East Street and Henry Street Five Dock Heavy Vehicle Route

SMWSTCTP-AFJ-OLP-TF-RPT-000001 Revision 0

Sydney Metro West – Central Tunnelling Package

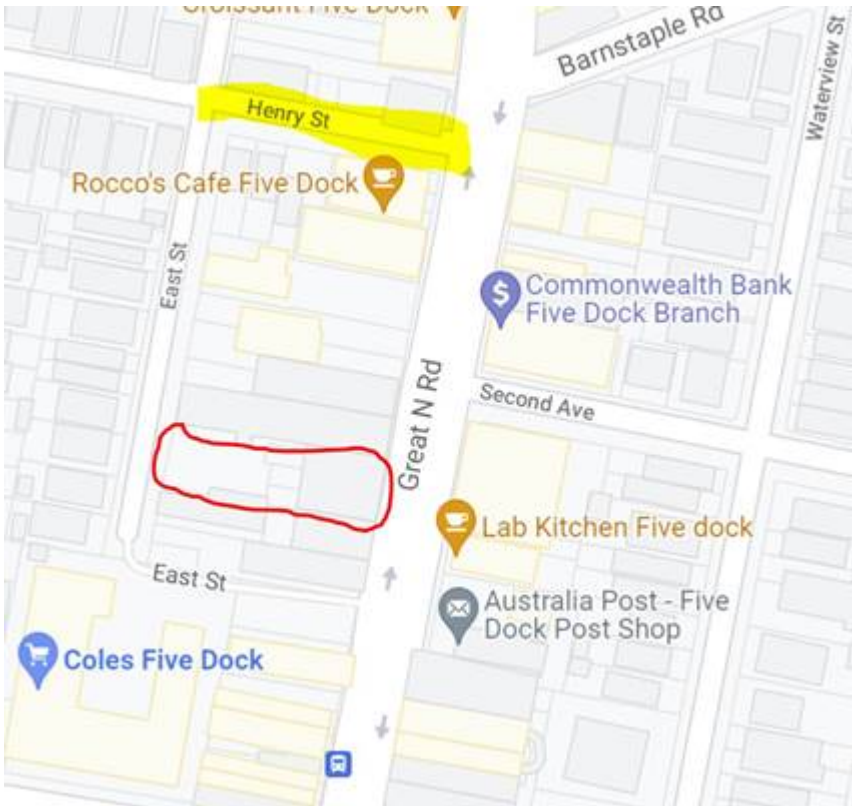
Separate to that our overarching CTMP does note during demolition that existing driveways will be used, and for these properties (shown below) there is no alternative to the driveways shown.

As for the scope of the heavies – its anticipated a skip bin changeover with a rigid truck on a daily basis into February and once practical the new driveway access from Great North Road will be constructed, and commence operation as soon as practically possible to avoid impact on residents. The highlighted section of Henry Street has already had the dilap completed last year in the figure below, the red is the carpark they are staging the demolition from, as you can see there are no driveways available directly to and from GNR so we are in a bind until an opening can be created.

I have received the feedback from Brendan saying that he doesn't have any issues if it is only 1 medium rigid (8.8m long) per day, but he wouldn't support a Heavy Rigid Vehicle (12.5m long) at this stage as it could not negotiate the corner of East Street and Henry Street intersection without mounting the footpath and/or being obstructed by parked cars.
